Delegated Report

Non-material Amendment and LB Consent Application

Planning Application Nos: 20220893 (NMA) and 20220833 (LB Consent)

Location: 6 Berkley Crescent and 48 Harmer Street, Gravesend, Kent

Proposed first and second floor flat layouts:

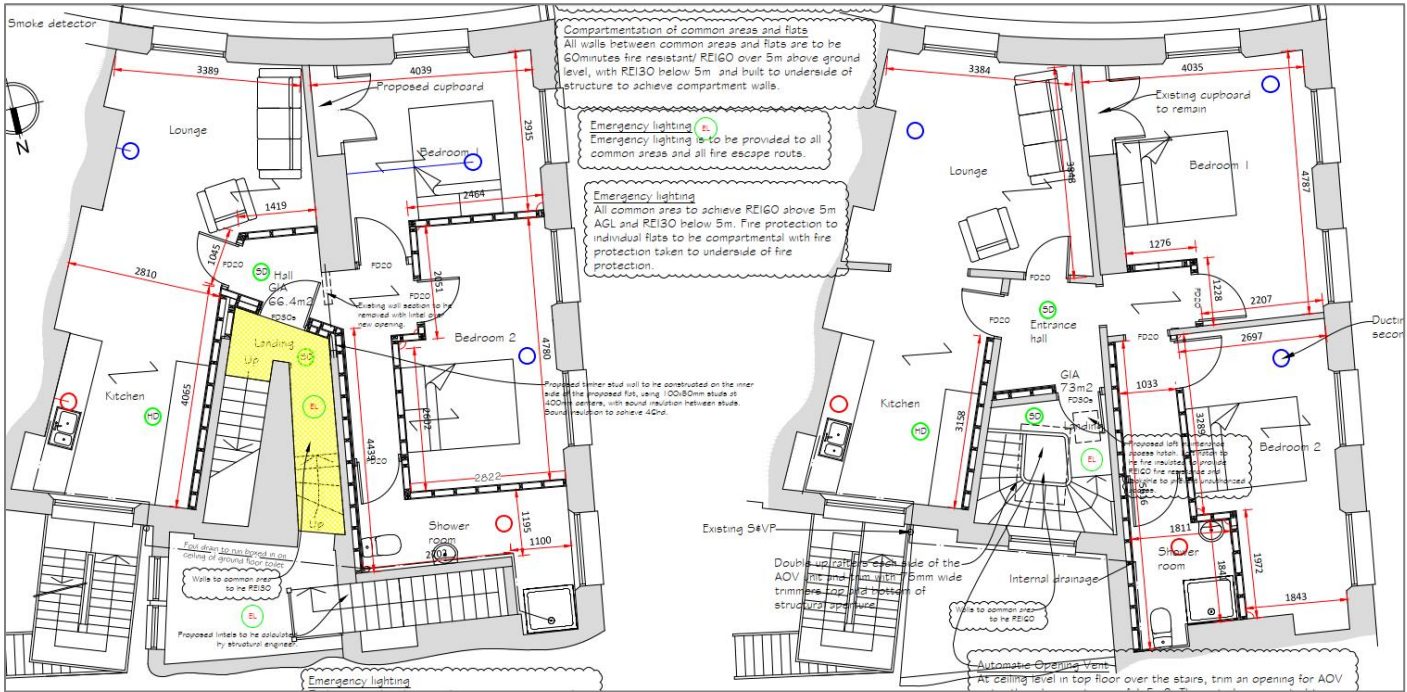
The proposed revised layouts seem to exacerbate the oblique angle of rooms – particularly on the first floor. This needs resolving. [Agent submitted revised plan on 30.11.2022.]

The relocation of the bathrooms needs to address the need for ventilation extractors which building regs will require. The previous layout offered the opportunity to duct to the rear but the new layout will not allow this. It needs further consideration. [Agent submitted revised plan with ducting provision on 20.03.2023.]

The proposal seeks to amend the internal layout after consideration of drainage runs by the building contractor and also by the Building Control Inspector. The proposal to move the bathrooms to the northern end of the buildings enables a drain run through the floors to the rear of the flats and then across under the ceiling in the ground floor toilet at the rear of the property, and then to the foul drain run connected to that toilet.

Proposed rear elevation:

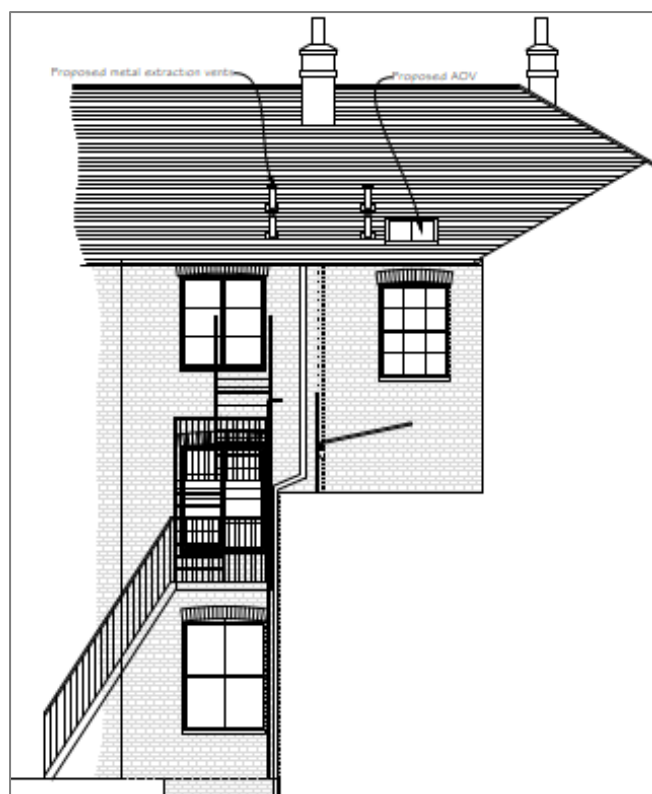
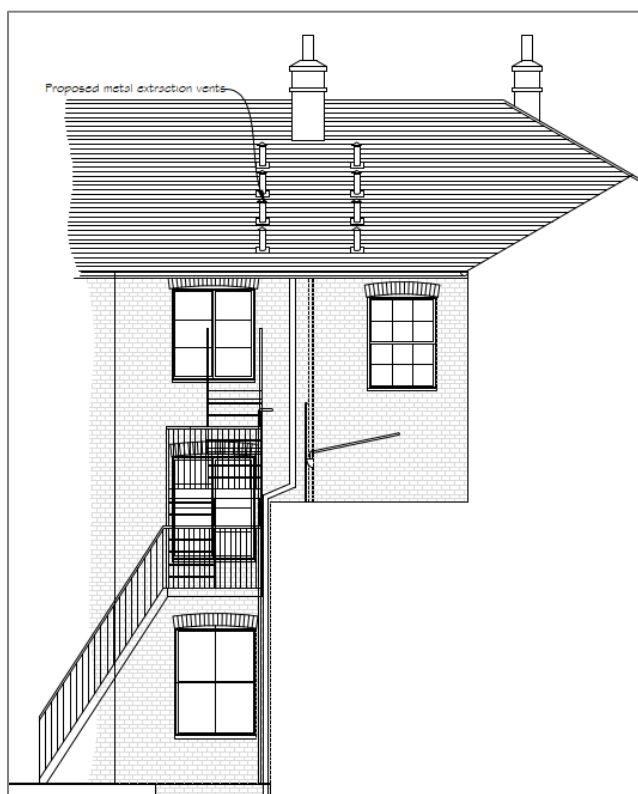
Detail required for automatic opening vent in the ceiling above stairs. [Agent submitted additional plan on 26.09.2022.]

Additionally, Building Control require that an automatic opening vent (AOV) is installed over the staircase to the flats and is proposed within the rear roof slope where it will not be visible from street level. This will be a conservation AOV so appear the same as a conservation velux, with a central glazing bar with a low profile frame. The frame will be aluminium and painted black.
